Access Compliance Report Public Rights-of-Way (Pedestrian Signals)

Main Street: **SANTA ANA_AVE** Cross Street: **MESA_DR** Location: **SE**

ADA ID: **SGAT220128175142** Signal Type: **One Push Button-Non APS** Overall Compliance: **No** Severity Scores: **BTN 1: 35** **BTN 2: N/A** **No BTN: N/A**

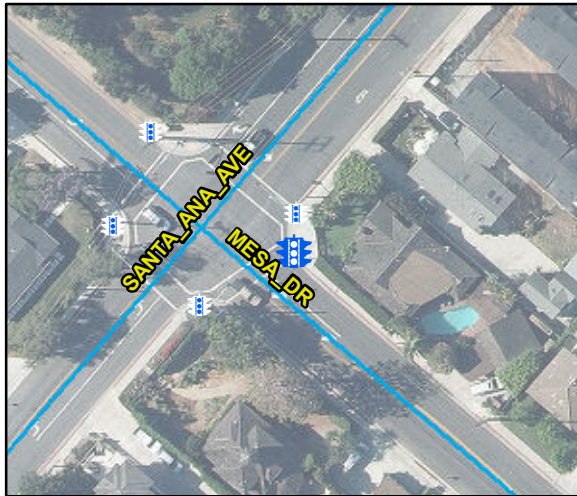
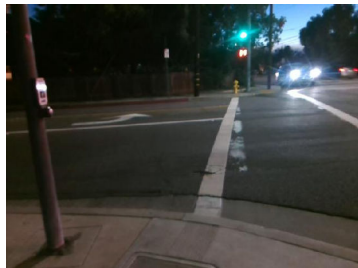
OC Std/PROW: **R404.2, R404.3, R403.4, MUTCD 4e.08**

Possible Solutions: Replace Signal Push Button With APS Button. Remove and Replace Clear Space.
